April 4, 2016

Re: Walt Ranch Development Project Final EIR

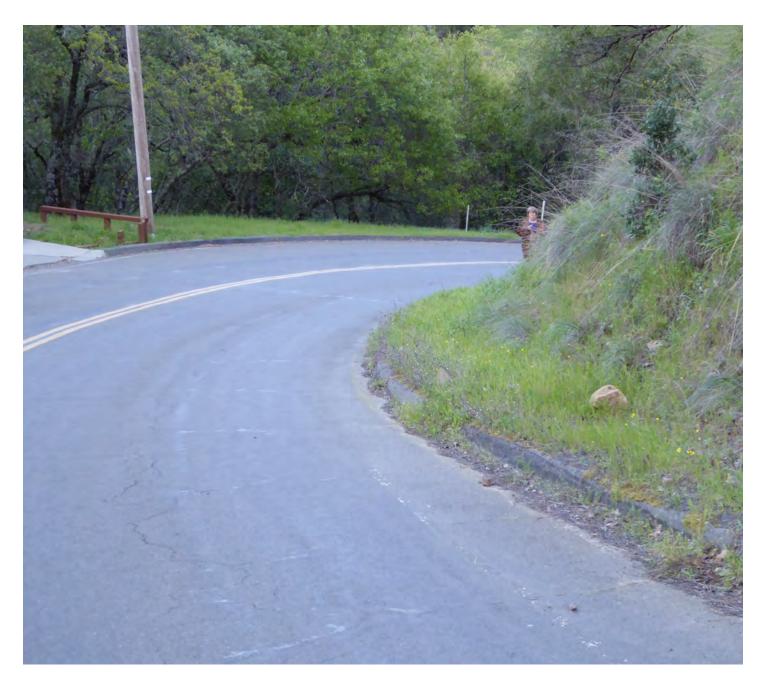
I have attached a picture of the S-curve, which not only shows the nature of the somewhat blind curve, but also road damage that appeared with a recent 10 day period of heavy rain that totaled 13 inches.

A second picture shows what a pedestrian would look like to a truck driver going down the slope 95 feet from the individual, the distance at which a pedestrian would first appear to a careful driver whose eyes were fixed on the road ahead. It is important to acknowledge that drivers of grape harvest vehicles are paid NOT BY THE HOUR, but by the weight and number of trips. No reasonable person should expect that a suggested 15 mph speed will be observed.

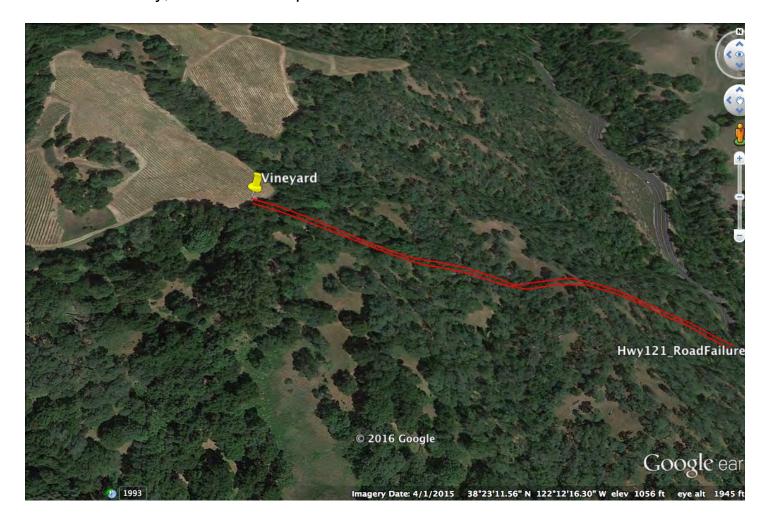
I have attached a graphic I created of the March 2016 road failure on Hwy 121 located 1½ miles south of Circle Oaks. The big question is what role the vineyard located 400 yards from the road loss contributed to this multimillion dollar repair project. The washout occurred because of an accumulation of water on the western (vineyard) side of the road (NOT from the creek below UNDERcutting the road, as has occurred in the past). There is a swale that begins far above, and deposited the water right at the location of the road failure. The vineyard above that undoubtedly contributes water to this flow is planted in a downhill direction that appears to intensify water runoff. Where is the directionality of vineyard planting discussed in the Walt Ranch FEIR? This is the very risk faced by the Circle Oaks community, with similar slope and similar soil.
